Project	IEEE 802.16 Broadband Wireless Access Working Group < http://ieee802.org/16 >	
Title	Clarification of SNR definition for MIMO	
Date Submitted	2005-03-13	
Source:	Ming Jia,, Peiyong Zhu, Wen Tong, Jianglei Ma, Mo-Han Fong, Hang Zhang, Brian Johnson Nortel Networks 3500 Carling Avenue Ottawa, ON. K2H 8E9 CANADA	Voice: (613)-765-8089 Fax: (613)-765-7723 pyzhu@nortelnetworks.com
Re:	Working Group Letter ballot 17 on P802.16-2004/Cor1/D1	
Abstract	In this contribution, we propose to feedback CQI based on SNR measured after MIMO decoder and before FEC encoder, so called post processing SNR to provide a unified approach for MIMO CQI measurement. In the proposal, we also clarify the multiple layer feedback using CQICH_Alloc_IE() or Enhanced_CQICH_Alloc_IE() . The updates are in green font.	
Purpose	The contribution should be considered by Maintenance group within comment resolution procedure	
Notice	This document has been prepared to assist IEEE 802.16. It is offered as a basis for discussion and is not binding on the contributing individual(s) or organization(s). The material in this document is subject to change in form and content after further study. The contributor(s) reserve(

Figure XXX Post processed S/N for MIMO

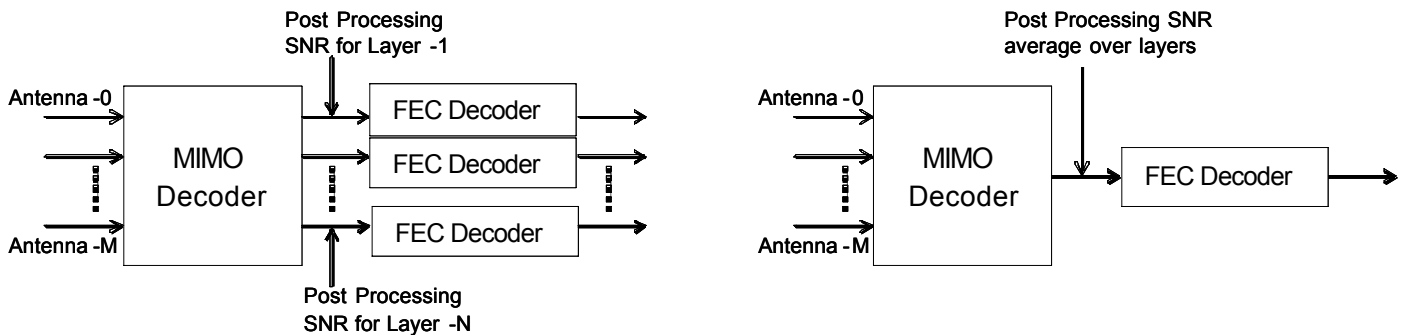
Insert the following text at the end of section 8.4.5.4.10.1

MIMO capable MSS shall measure post processing S/N for each individual layers as shown in Figure xxx. When the FAST_FEEDBACK subheader Feedback Type field is “00”, the MSS shall report the post processing S/R averaged over layers. When BS requests MSS feedback through CQICH_Alloc_IE() or CQICH_Enhanced_Alloc_IE() with ‘00’ Feedback_type field, MSS shall report average S/N or individual layer S/N as described in sections 8.4.5.4.12 and 8.4.5.4.15
